**Comments to the Lower Colorado River Authority (LCRA)
regarding revisions to the 2015 Water Management Plan
for the Highland Lakes**

Comments to LCRA regarding revisions to the 2015 Water Management Plan

LCRA Water Management Plan Update Process: Participant comments through Aug. 31, 2018, and LCRA responses

Figure 3. Effects of Vista Ridge, End Op, Forestar, and LCRA Power Plant Pumping on Groundwater and Surface Water in the Lost Pines GCD and Post Oak Savannah GCD

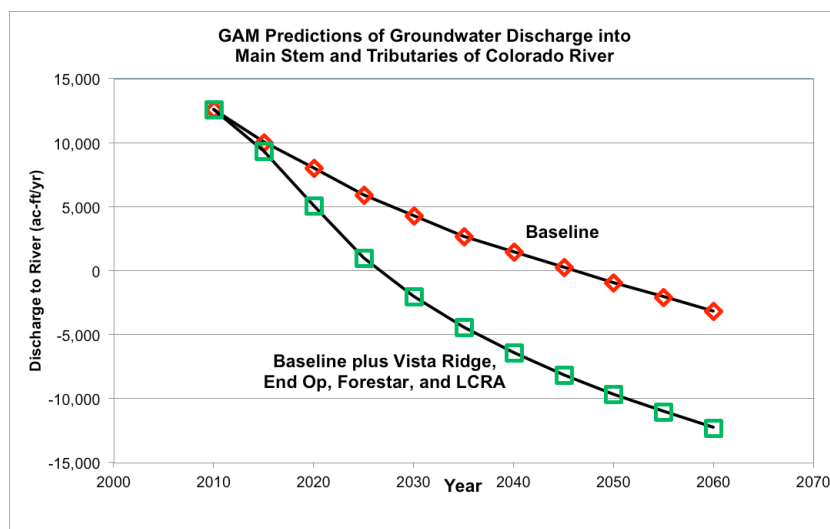
The current groundwater availability model (GAM) predicts⁶ that groundwater pumping in the Simsboro Aquifer will affect the Colorado River and its tributaries by decreasing the amount of groundwater that currently go into the river (Figure 3). The model predicts that during the fifty-year planning period both baseline and permitted pumping will cause the river segments in the Utley-Bastrop-Smithville reach to reverse from being primarily a "gaining" stream to become a "losing" stream. This reversal will have a significant impact on environmental flows during dry and extraordinary drought periods, especially if LCRA requests emergency exemptions for interruptible water from the Highland Lakes into the lower basin as was the case during the last drought.

ES REQUEST 1: Environmental Stewardship requests that the LCRA use the improved GMA-12 GAM to better estimate the impacts of groundwater pumping in the Simsboro Aquifer on the Colorado River and its tributaries in the Austin-Bastrop-Smithville reach to inform the current water management planning process on the potential impacts of such pumping on the overall Highland Lakes system.

LCRA's response: *Interactions between groundwater and surface water are outside the scope of the WM Prevision.*

Figure 4. Colorado River at Bastrop gage during drought period Jan.2011 - Dec.2013

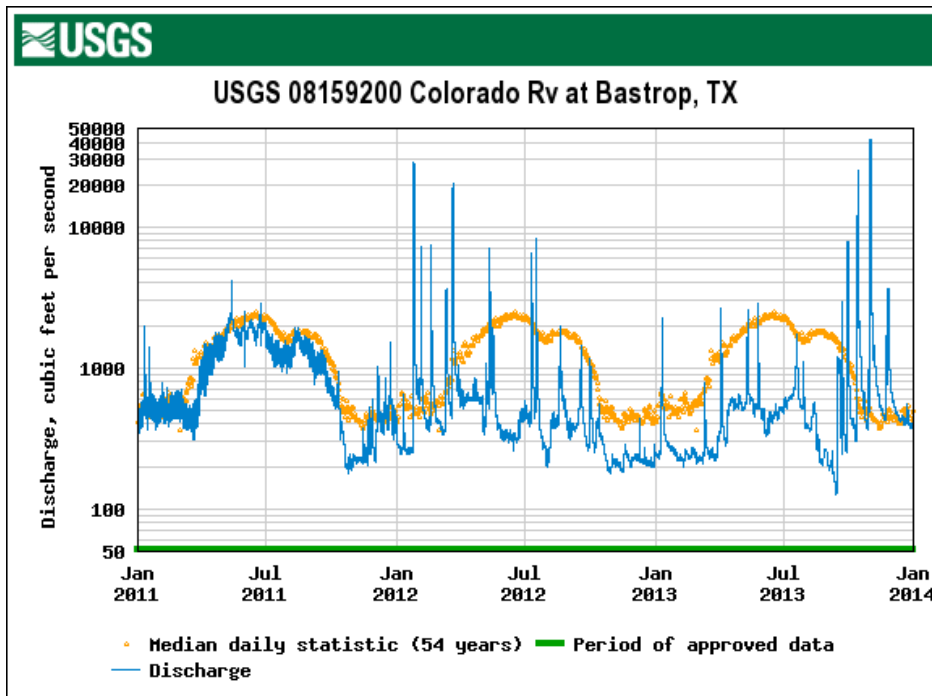
Figure 4 is a hydrograph of the three year drought period from January 2011 through December 2013 when the region experienced some of the most severe drought conditions in decades. The distinguishing feature of this figure is that in-stream flows benefitted from the irrigation releases for down-stream rice farming during the spring, summer, and early fall of 2011. Irrigation water was curtailed during the 2012 and 2013 irrigation seasons. Note, however, that there was very little flow from rainfall during the 2011 period. Lacking irrigation flows, flow in the river for the summer and fall would likely have dropped into the 120 cfs critical environmental flow range during that period.

A hydrograph separation on the three year period represented in Figure 4, with irrigation releases removed, would likely reveal a very good estimate of actual groundwater outflows to the river from the Carrizo-Wilcox Aquifer group. During this period the bank storage for the river had likely been exhausted and the river was relying on the minimum flows passing through the Austin gage at Longhorn Dam, City of Austin return flows, and groundwater base flows. Environmental Stewardship attempted to fund a USGS gain-loss study from Utley bridge to Matagorda Bay during that period to provide current period groundwater outflow estimates for purposes of calibrating GAM and WAM models.

ES REQUEST 2: Environmental Stewardship requests that the LCRA prepare the hydrographic separation as described above for the period January 2011 through December 2013 for the Bastrop and Wilbarger gages of the Colorado River to gain insights on the quantity of groundwater that was being contributed to river flow for this extraordinary drought period.

LCRA's response: *Determining the amount of groundwater that may have contributed to base flows in the Colorado River is outside the scope of the WMP revision. Environmental Stewardship may wish to review the naturalized flows for the Colorado River, which include numerous dry periods over the period of record, including recent drought years.*

Figure 5. Colorado River at Bastrop gage during drought period Oct. 2012- Sept. 2013

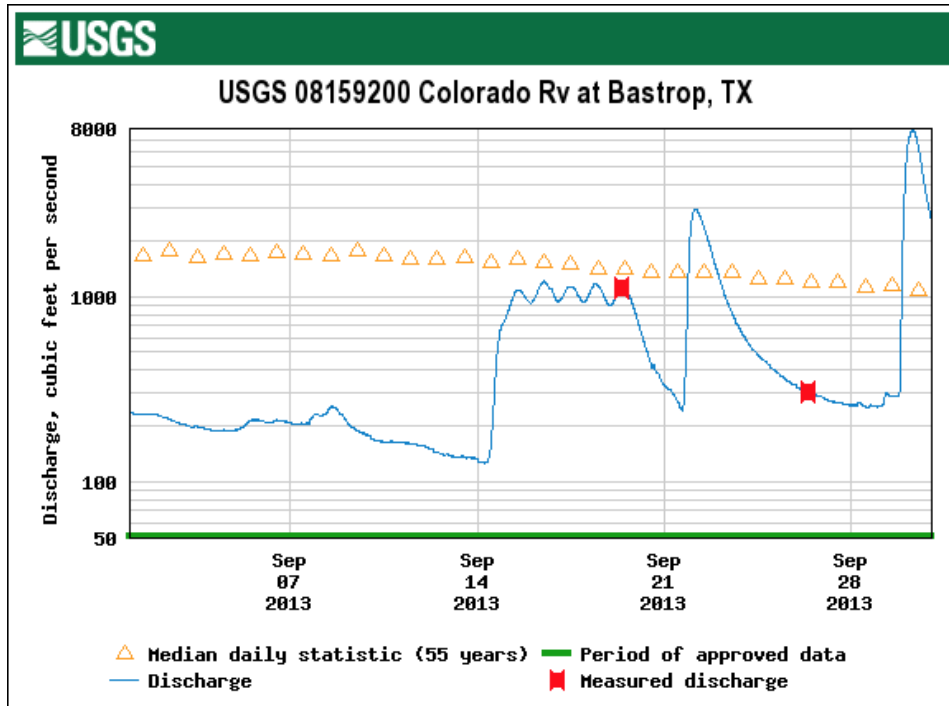
Figure 5 is a hydrograph of the month of September, 2013 when the flow was trending toward the critical in-stream flow minimum. Fortunately, the region received significant rainfall starting in mid-September and river flow rebounded.
